**RE: Addendum #2 25-02 Southport Sports Complex**

Please accept this as Addendum No. 2 for the above referenced solicitation.

For clarification purposes, **please see revised and additional drawings:**

**PAVILION ROOF FRAMING PLAN**  
 SCALE: 1/4" = 1'-0"

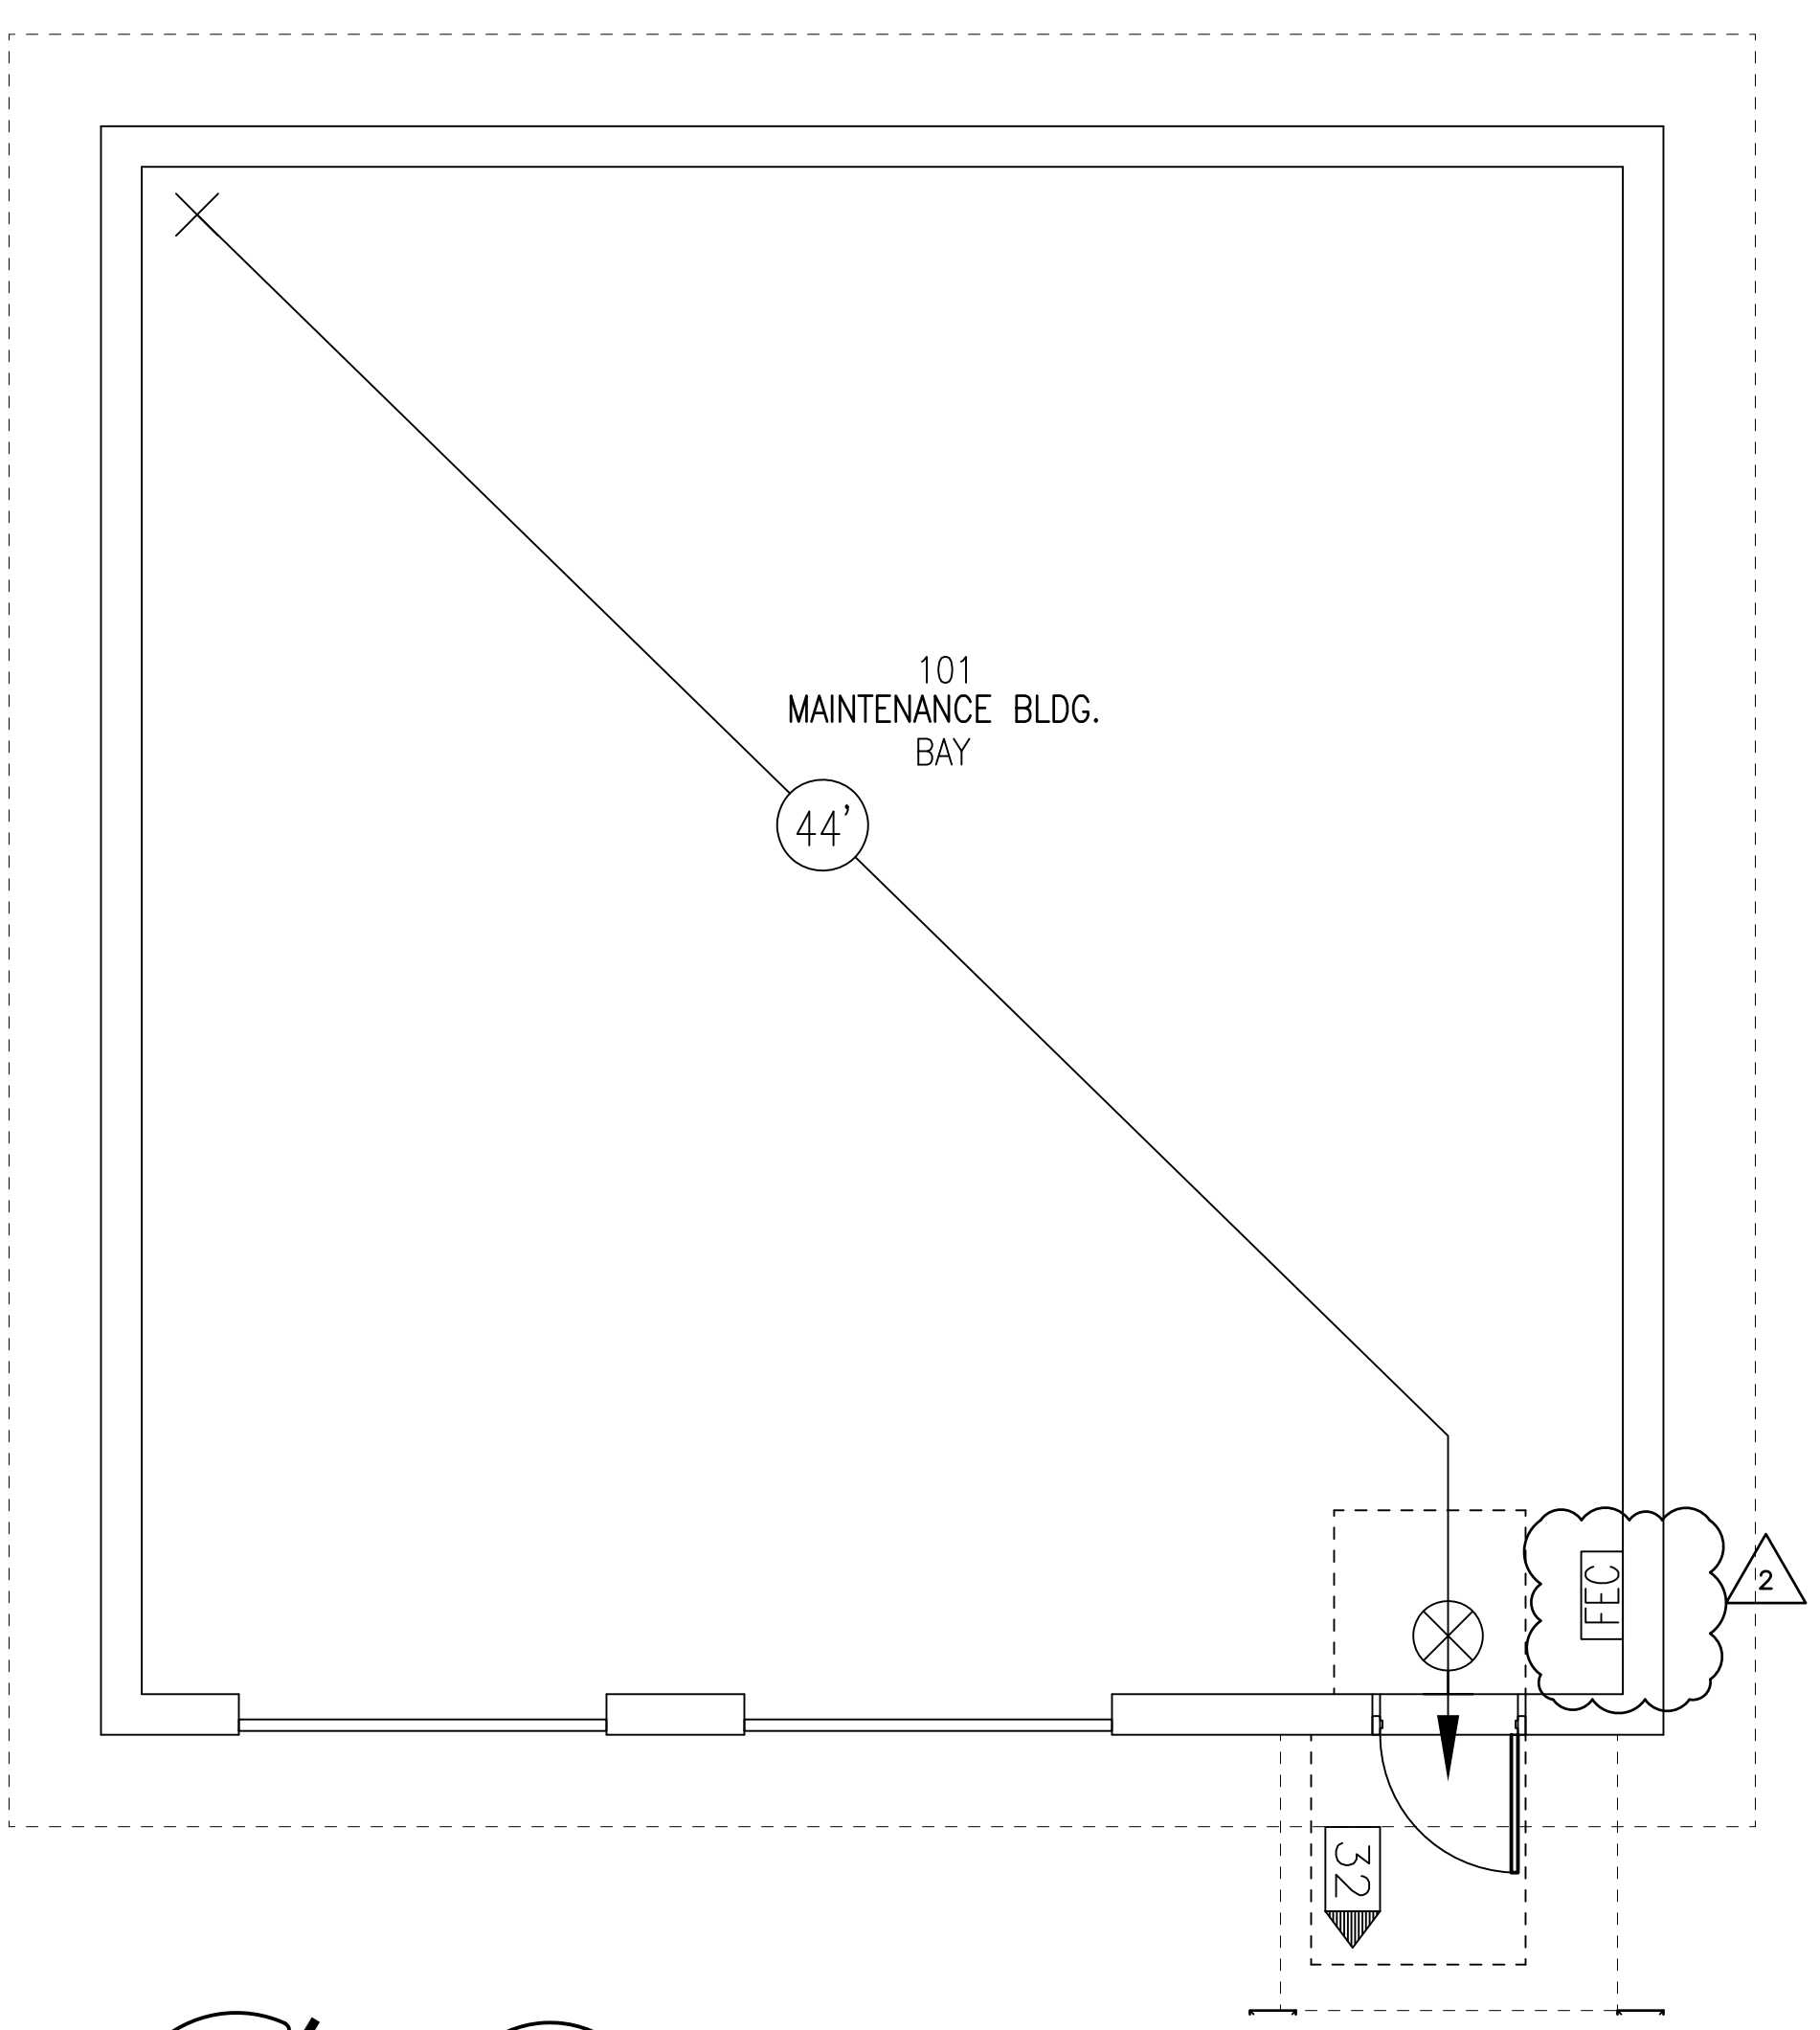
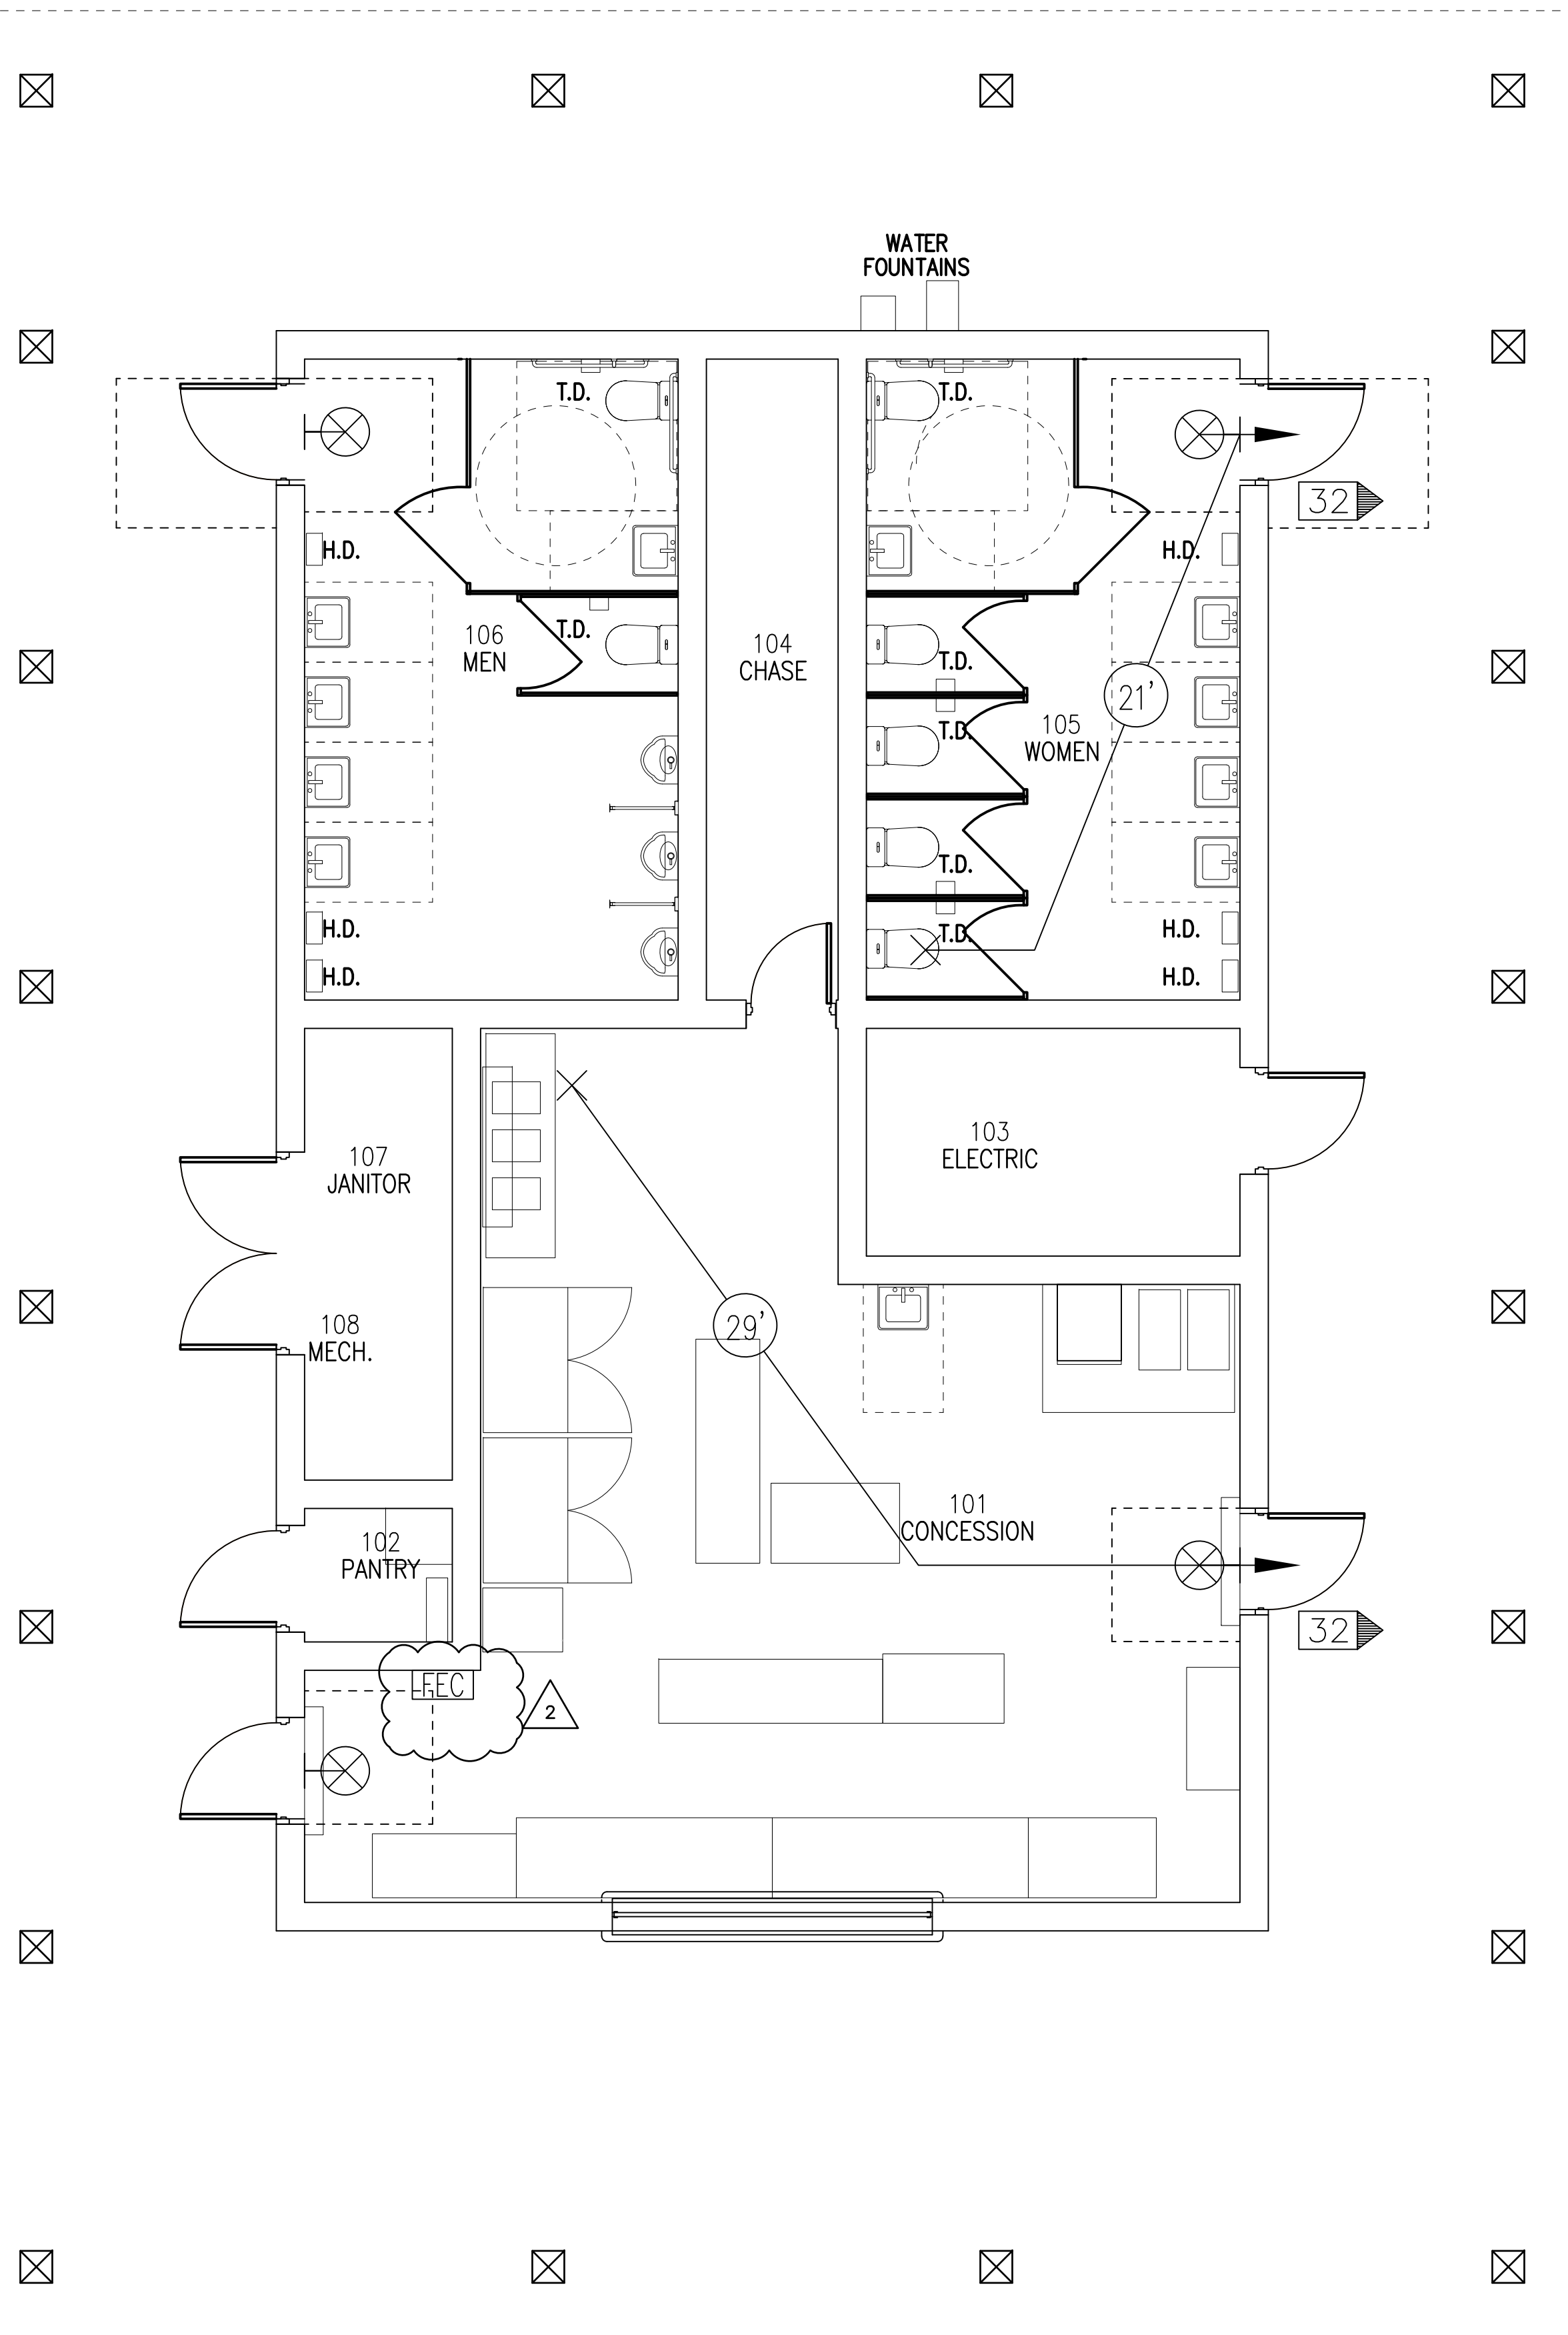
18. Framing detail on S3.1-F calls for 8x8 PT posts on the Dugout but A2.3 and other notes call for 12x12 PT posts. Please advise which is correct. **12x12 PT posts are correct.**

REV.	OR	CHK.	DATE	DESCRIPTION
0	RK	WS	7/11/2022	ISSUED FOR PERMIT
1	RK	WS	10/15/2024	REVISED POST SIZE FOR DUGOUT
